From: [Greg Hathaway](#)
To: [Reynolds, Janice](#)
Cc: [Barry Cain](#); [Lita Grigg](#)
Subject: Wisser Development: Proposal does not provide sufficient Parking
Date: Friday, February 07, 2014 2:45:16 PM

G-400
LU 13-0046

Re: **Wizer Block 137 Redevelopment**
Transportation Evaluation
City of Lake Oswego File No: LU 13-0046
Mackenzie Project Number 2140028.00

PROPOSED CONDITION: OFFSET DRIVEWAY

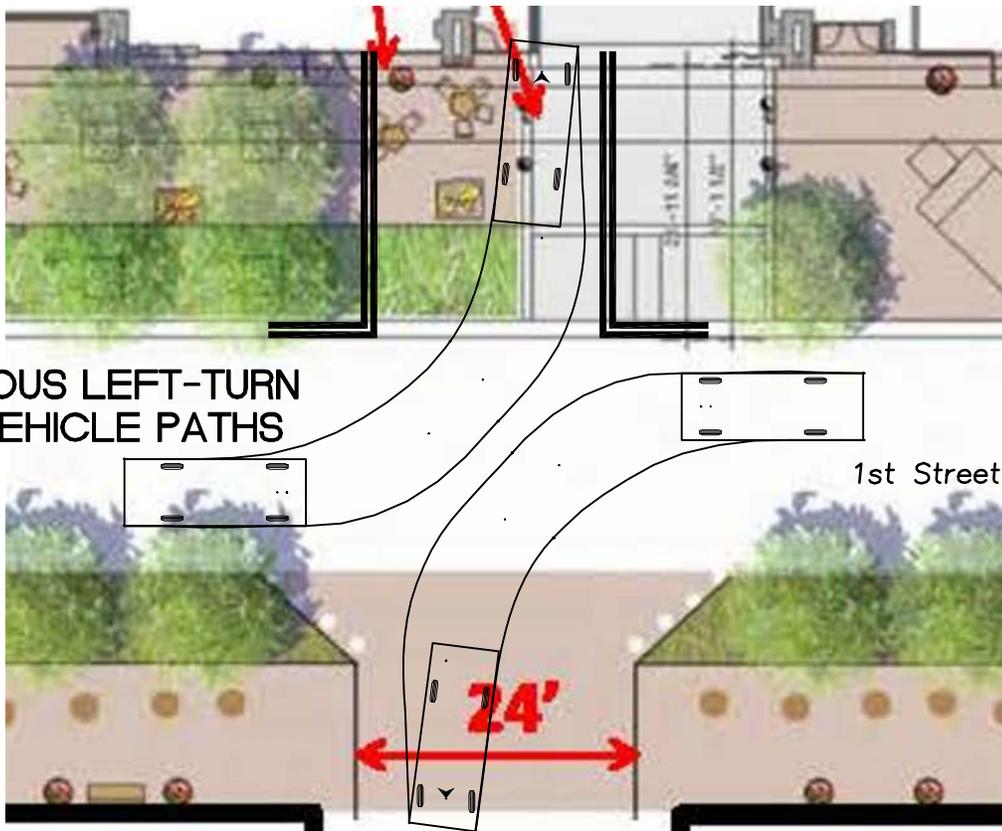
Mackenzie Response: As identified in the attached graphics, the centerline of the proposed 1st Street access is offset from the centerline of the Lakeview Village parking garage access by approximately 16.5 feet. This is not as close as possible. As also depicted in the graphics, this offset creates left-turn movement conflicts, does not provide clear way-finding for pedestrians crossing 1st Street, and creates unsafe and unnecessary pedestrian conflicts.

CONFLICTING LEFT-TURN
ENTERING VEHICLE PATHS

Overall, the centerline of the proposed 1st Street access should be aligned with Lakeview Village access. This alignment minimizes conflicts and ramp grade issues. Further, the proposed offset may result in turn restrictions – resulting in only

DESIRED CONDITION: ALIGNED DRIVEWAY

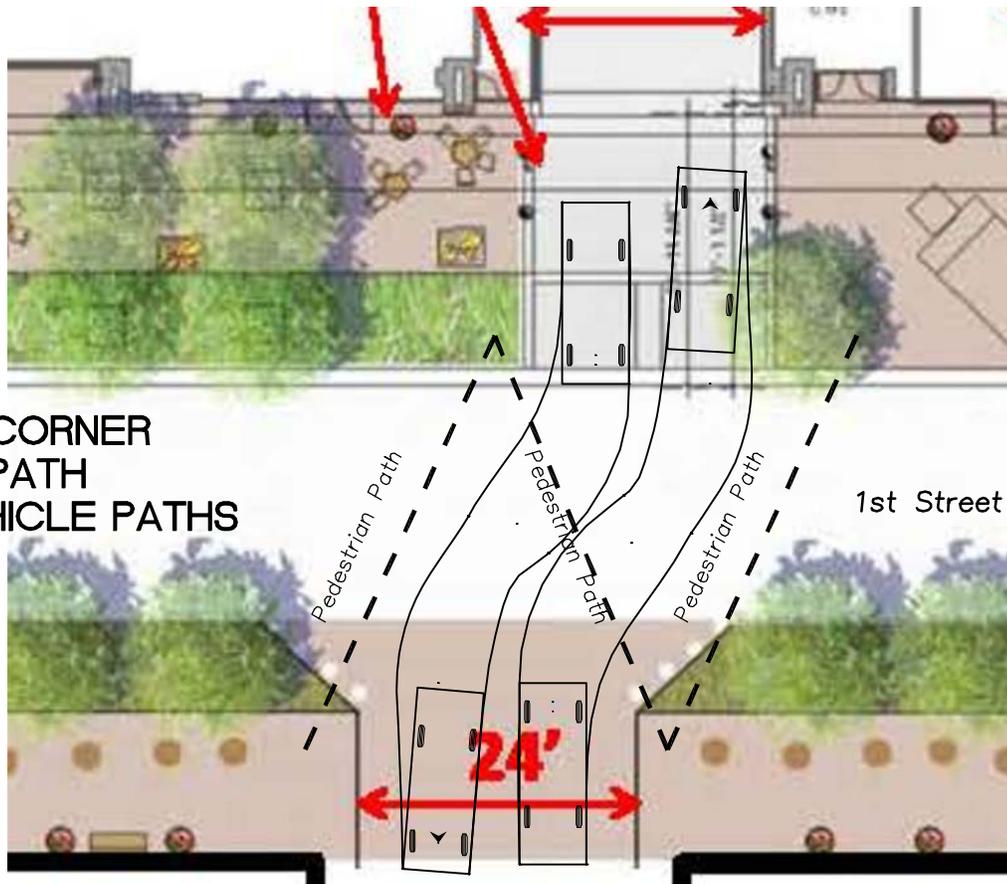
SIMULTANEOUS LEFT-TURN
ENTERING VEHICLE PATHS

PROPOSED CONDITION: OFFSET DRIVEWAY

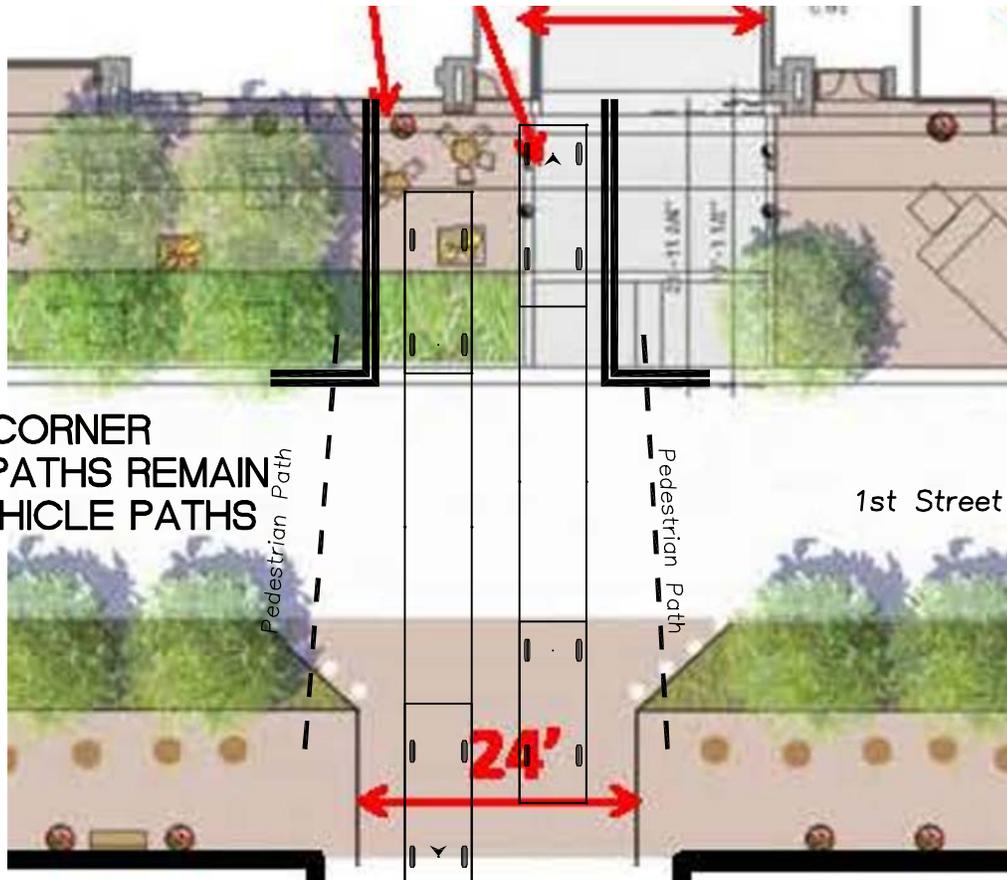
CORNER-TO-CORNER
PEDESTRIAN PATH
CROSSES VEHICLE PATHS

DESIRED CONDITION: ALIGNED DRIVEWAY

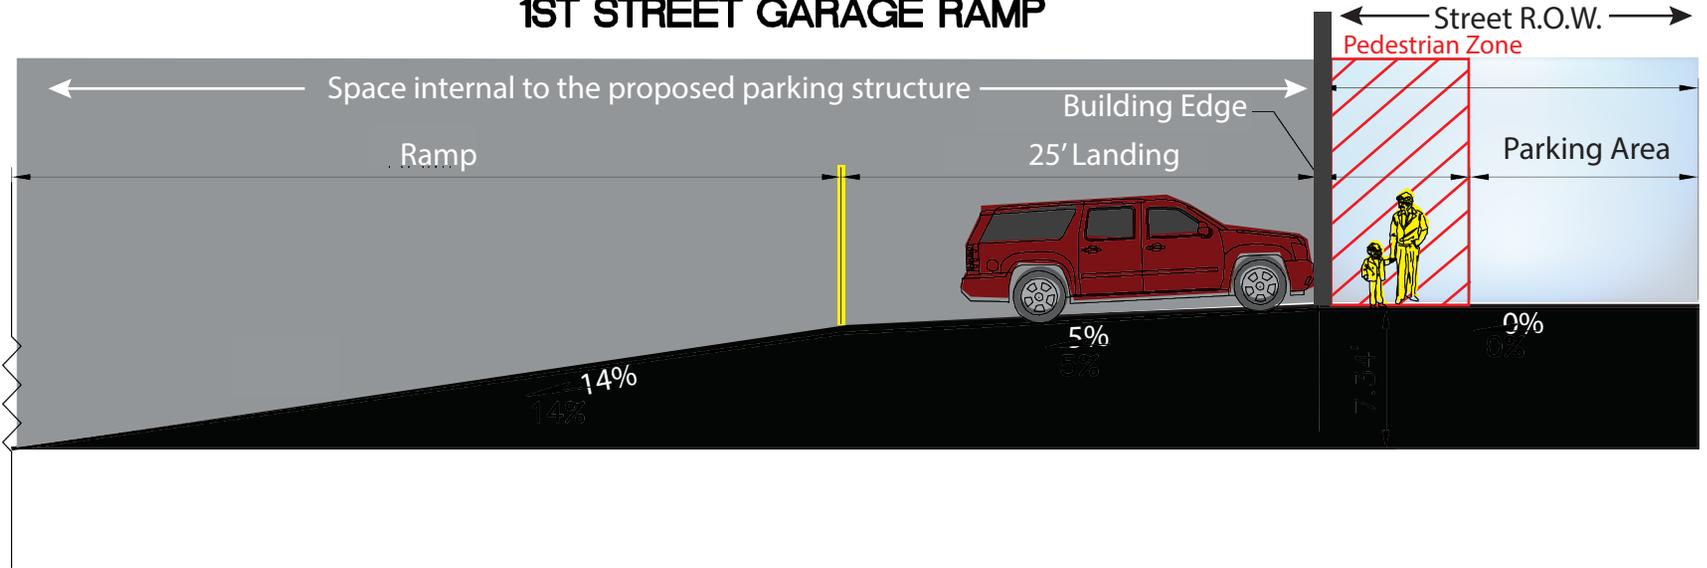
CORNER-TO-CORNER
PEDESTRIAN PATHS REMAIN
CLEAR OF VEHICLE PATHS

1ST STREET GARAGE RAMP

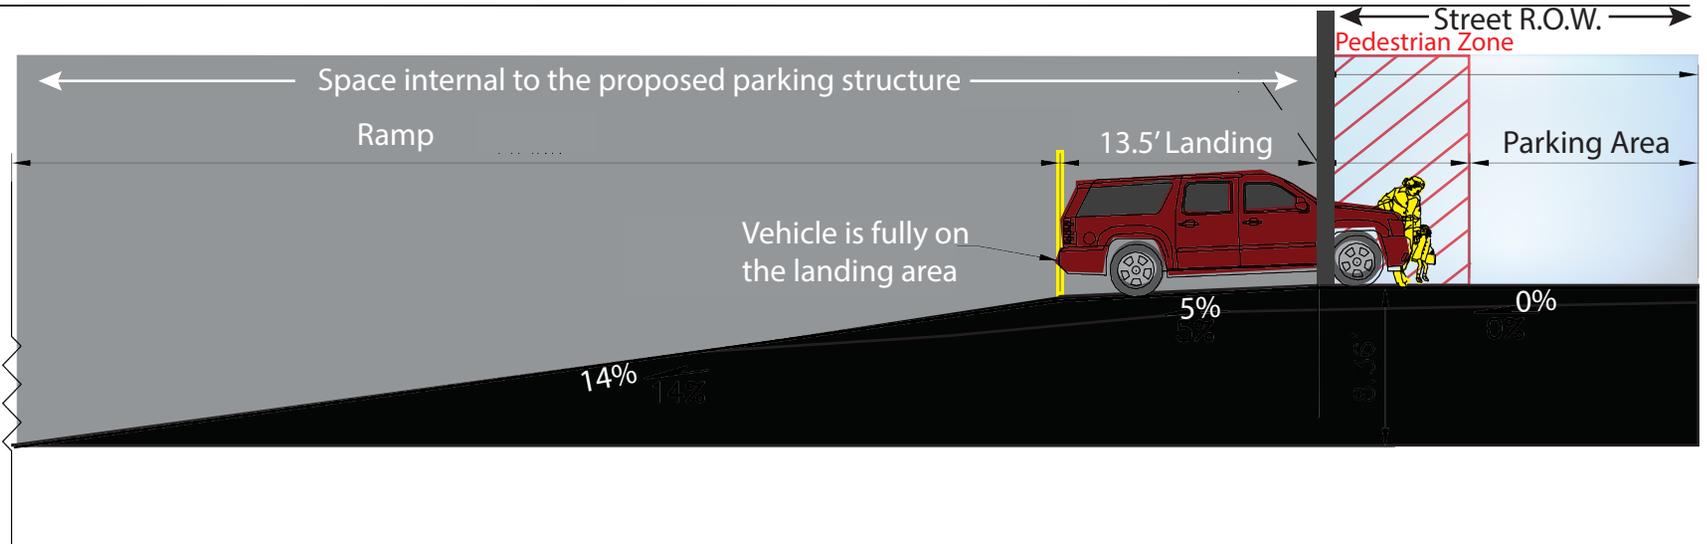
Mackenzie Response: In addition to the proposed vertical curves, the Applicant is requesting a LOC variance to the 1st Street access ramp design, which requires the landing area be a minimum of 25 feet long with a maximum grade of 5% and that the landing area be *outside right-of-way* (i.e., inside the proposed building). The Applicant's recently submitted Tab 2 graphic (Drawing C1.1) **incorrectly** identifies the location of the landing and transition areas, which should be measured inside the building as identified in the attached graphic.

Notwithstanding the exhibit error, the Applicant is proposing an approximately 13.5-foot-long landing area, which is significantly less than the LOC-required 25 feet. This landing does not provide a sufficient vehicle queuing area behind the sidewalk, and pedestrian safety is compromised – this is illustrated in the attached graphic. And as previously identified, 1st Street is a *primary pedestrian way* and safety is paramount; therefore, the variance should not be granted.

Referring to Item A above, if the access is aligned with the Lakeview Village access, there are fewer ramp design issues. And overall, a variance to the 1st Street access ramp design is not necessary, nor should it be granted. All proposed ramps accessing/crossing a *primary pedestrian way* need to meet LOC design standards.

SECTION - 1st STREET GARAGE RAMP
SCALE: 1" = 50'

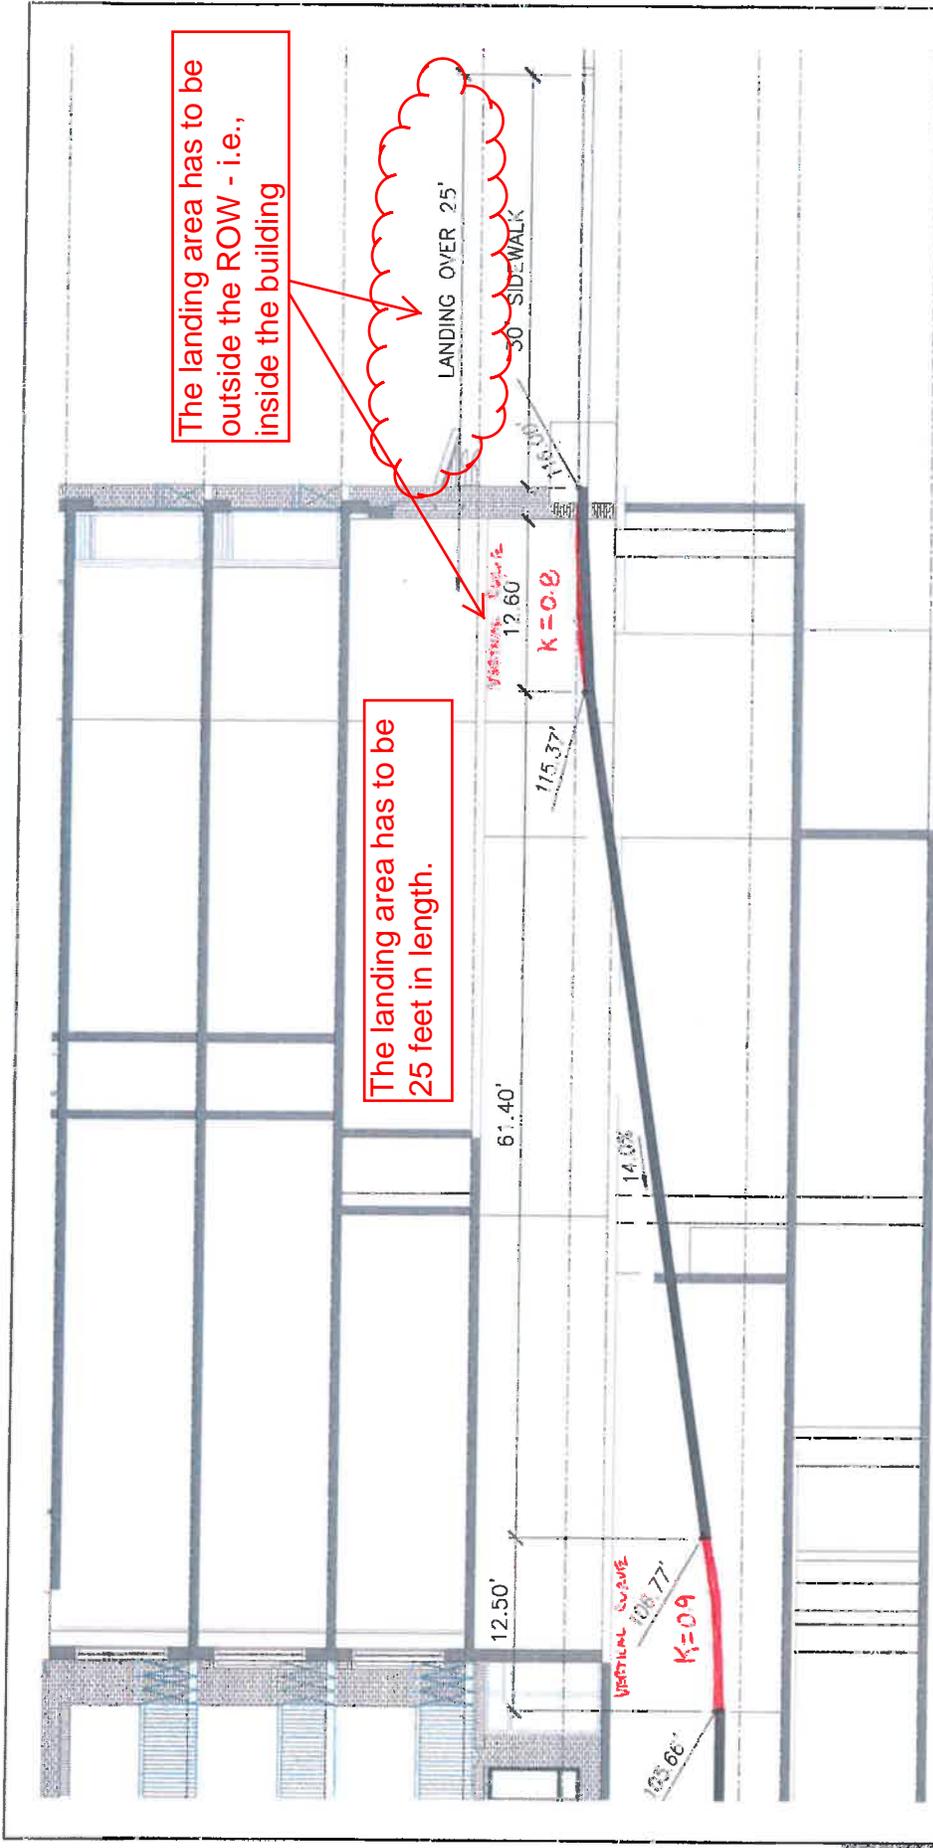
The Applicant has submitted a Tab 2 graphic (Drawing C1.1) showing the proposed vertical curves to address DRC comments.
